CS Memorandum No. 1324

To: Distribution
From: Susan MacKenzie, Document Control Manager 
Date: January 2, 2013
Reference: Project No. M544.1, Contract No. CS-149
Task No. 1-8.02, Change Control
Subject: Configuration Management Board Meeting No. 105

SUBJECT: Configuration Management Board Meeting # 105 – Rev. No. 0

05/22/2012
Removing asphalt and concrete base on
the south end of the Launch Box

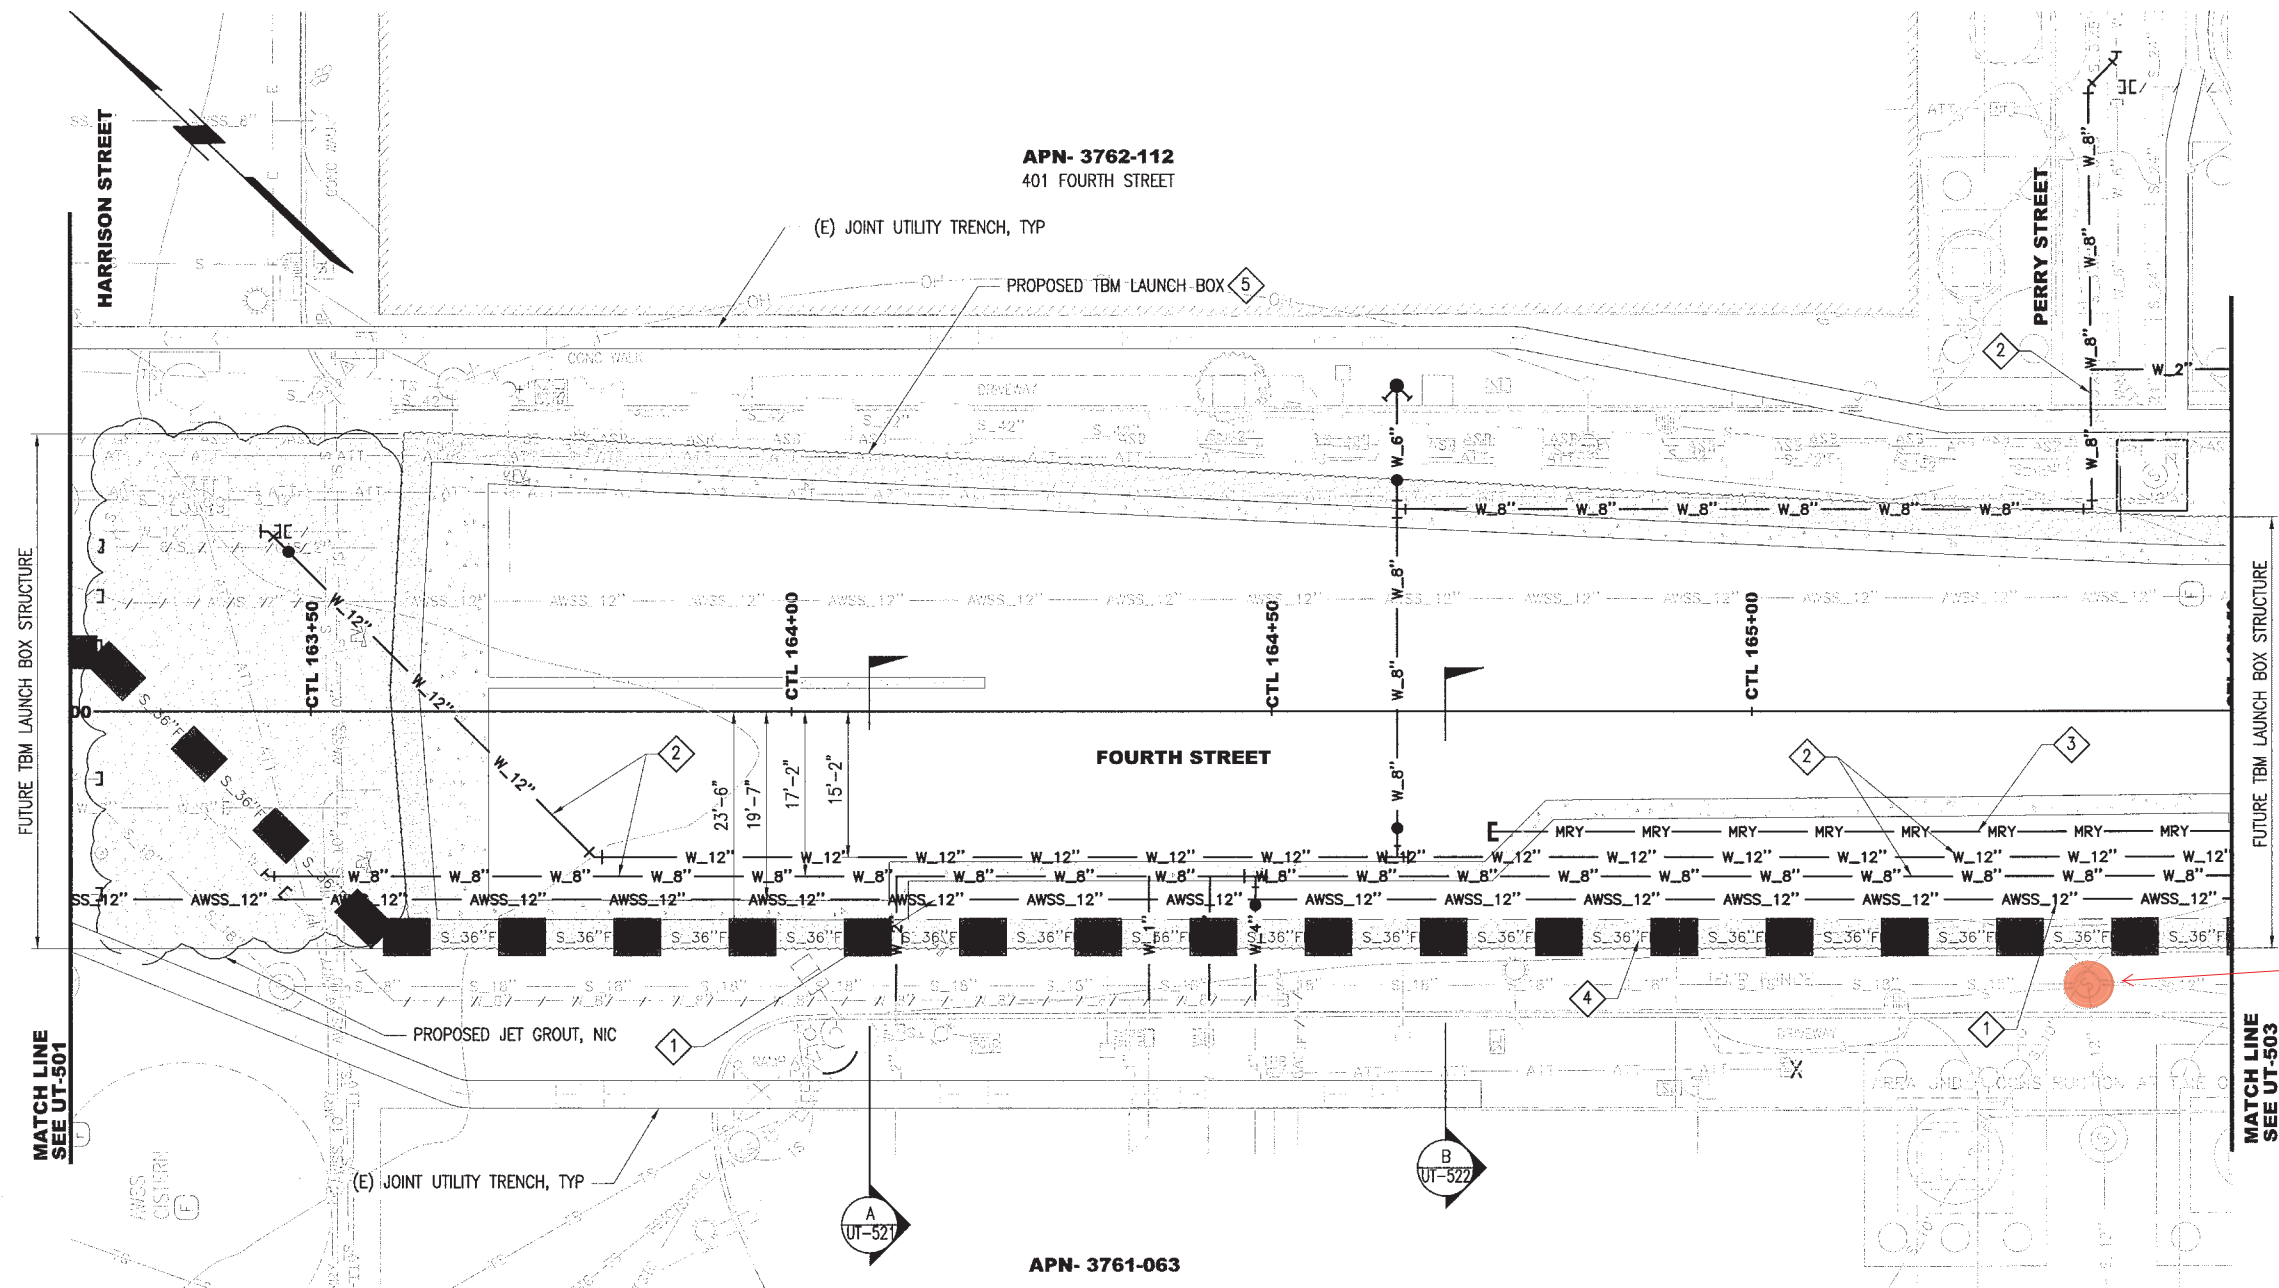
Justification: The road base is not a differing site condition as it is not different materially from conditions ordinarily encountered and generally recognized as inherent in the work of the character provided for in the Contract Documents. Any contention that additional labor and equipment were utilized should be rejected out of hand due to total volume of hole excavation remaining unchanged.

09/18/2012
16" stality that was encountered not shown on the UD plans to be abandoned on the Southeast Headwall of MOS

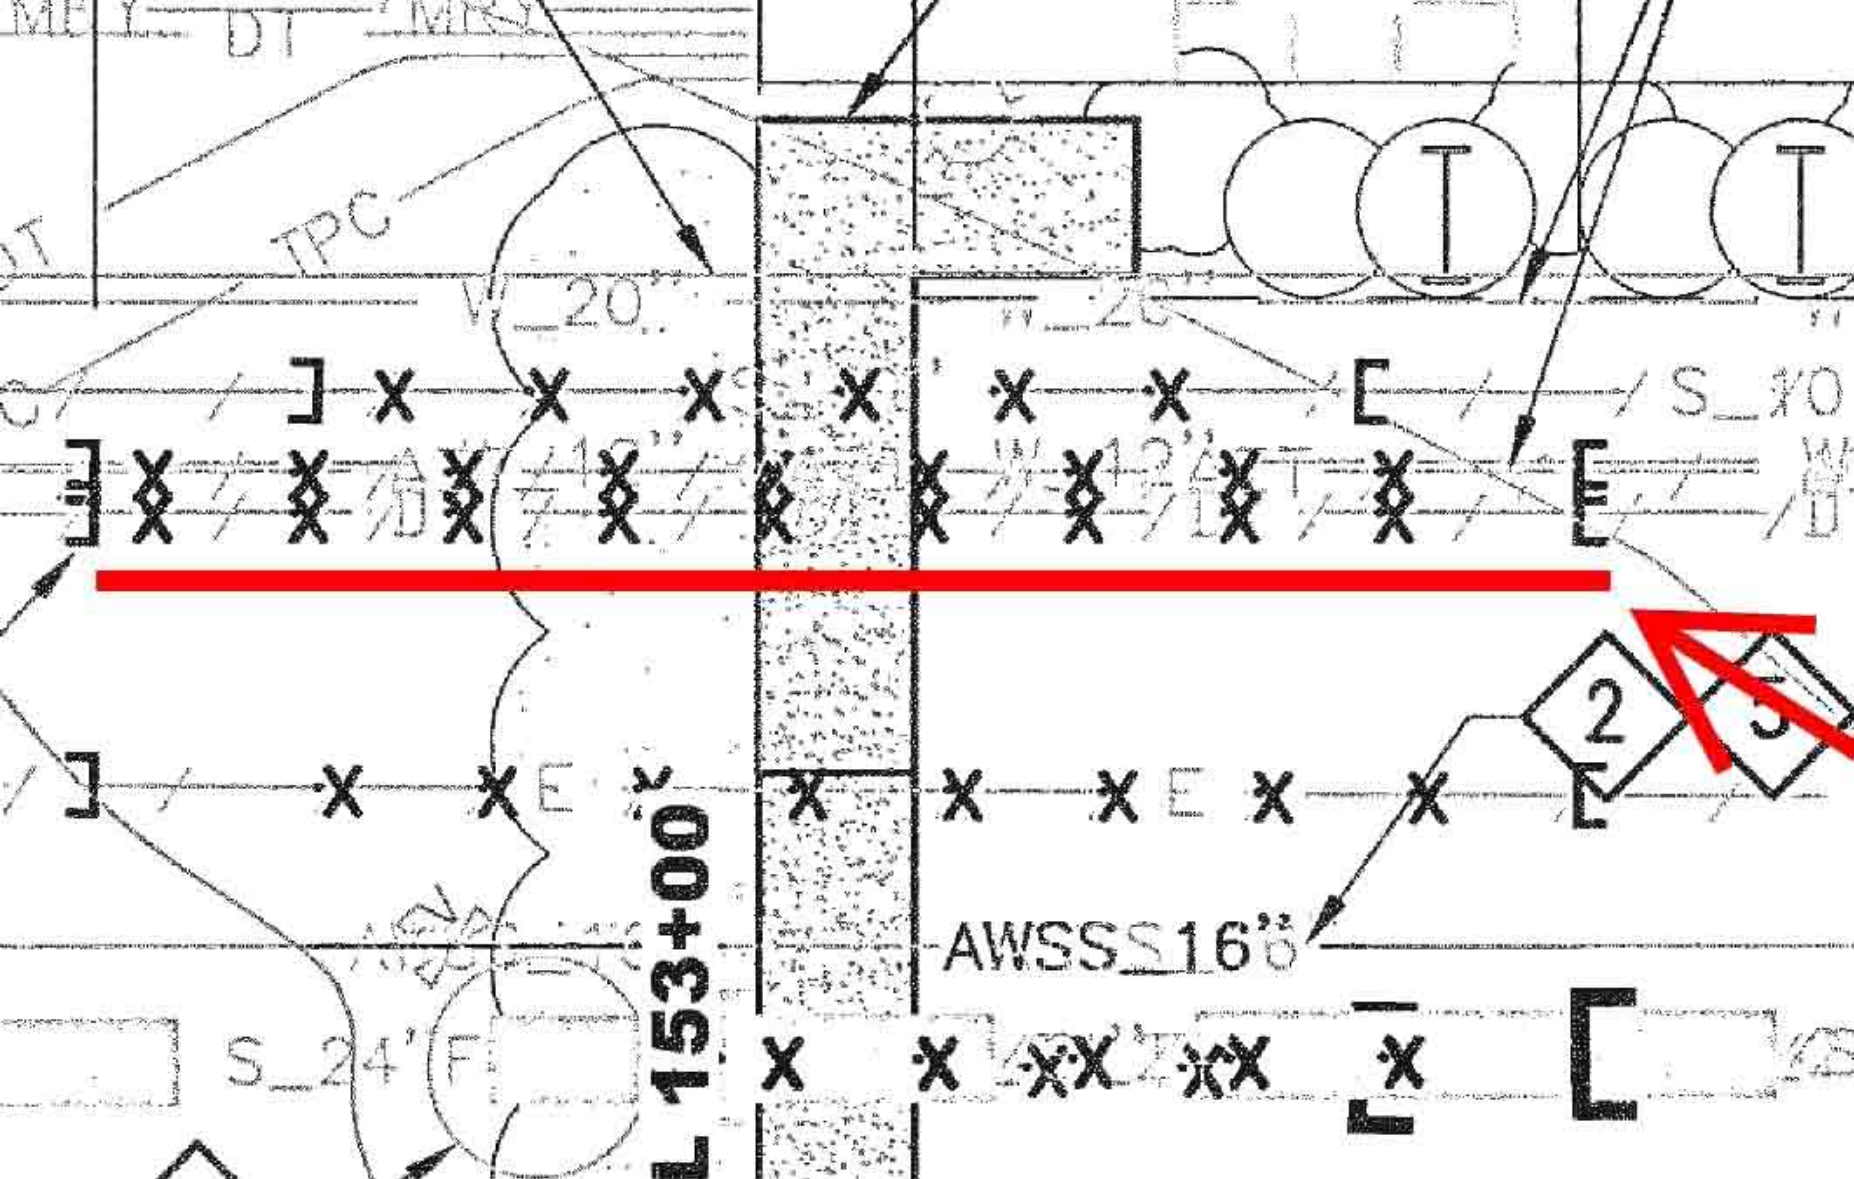
Contractor Rationale for COR: The Contractor contends that the pipe constitutes a differing site condition, as it was not shown on the drawings at the time of bid.

Justification: RE has evaluated the conditions outlined in Article 3.04 and found that conditions differ materially and conditions have caused the scope of work to increase.

Live PGE electrical leaving the 2975 Vault verified by Tom Reimer

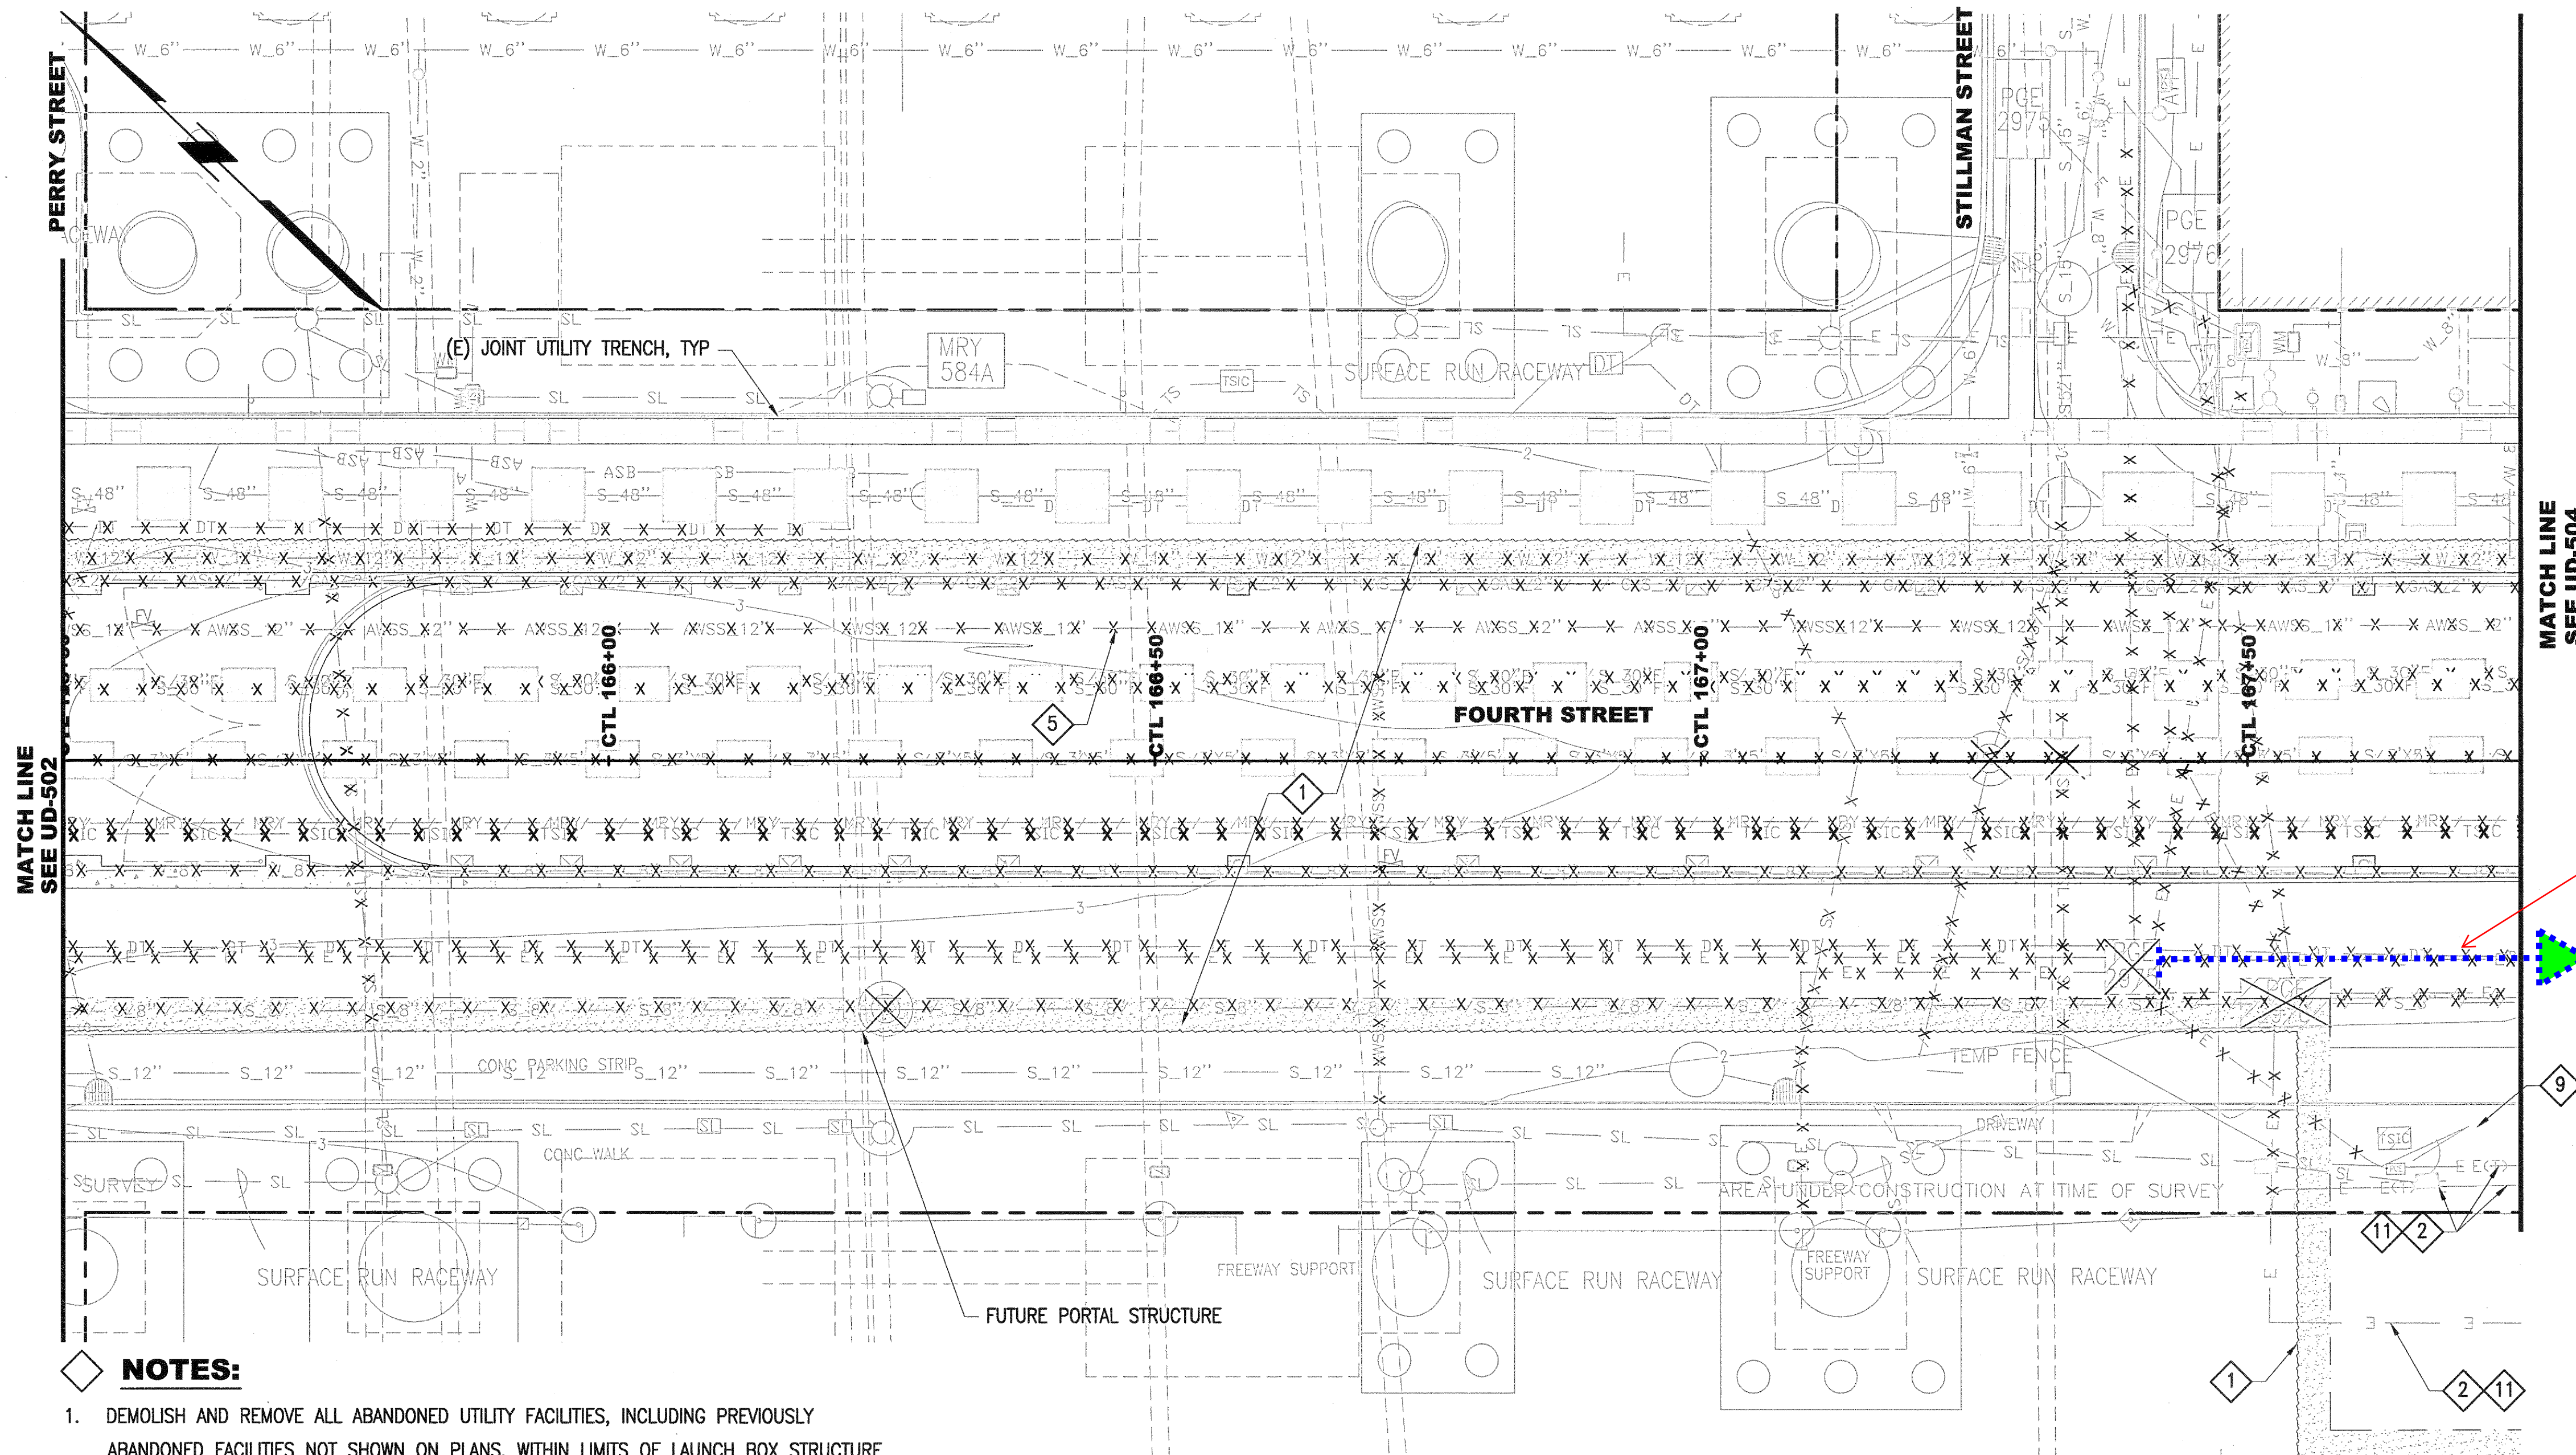
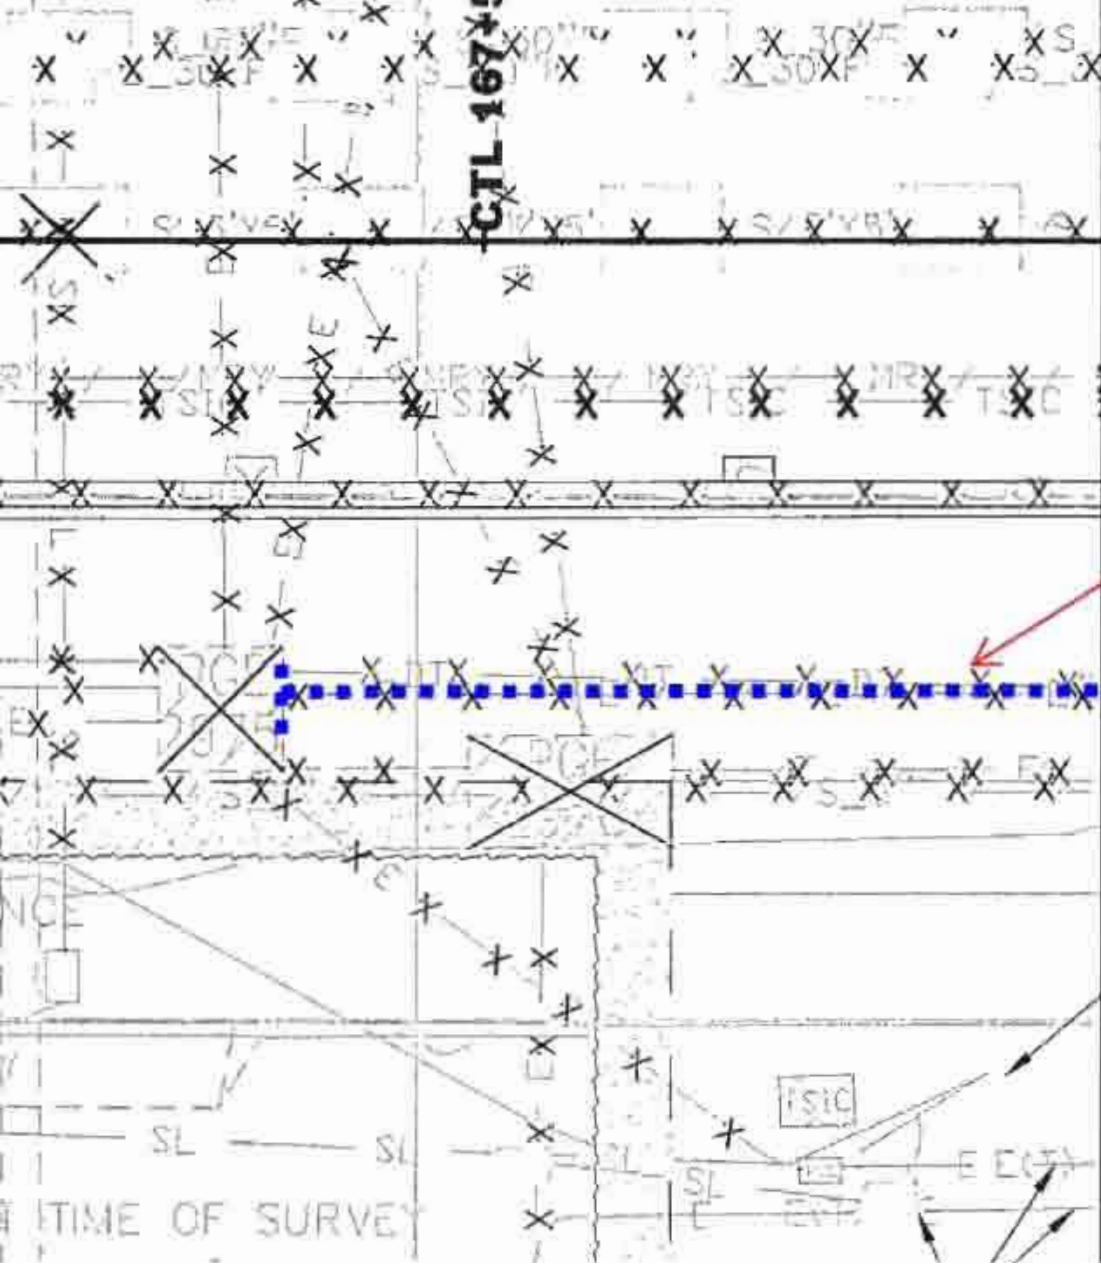
Recommendation: Accept Justification of Merit for COR 041 for providing a full time flagger for one night shift of work @ the intersection of the I-80 off-ramp.

Facts: On May 21st, based on direction from the SFMTA, BIH subcontractor Synergy Project Management (SPM) provided a full time flagger for one night shift of work @ the intersection of the I-80 off-ramp near 4th/Bryant streets.

Rationale for COR: BIH contends that the flagger was provided per the request of the SFMTA in order to facilitate PGE as required to finish the abandoning of the live power feed to the Launch Box area. SPM was told to track the costs and seek reimbursement afterwards.

Justification: PGE needed flagging assistance in the intersection of the I-80 off-ramp in order to access the PGE vault which provided power to the Launch Box area. The utilities leading from the vault were shown in the contract drawings to be abandoned.
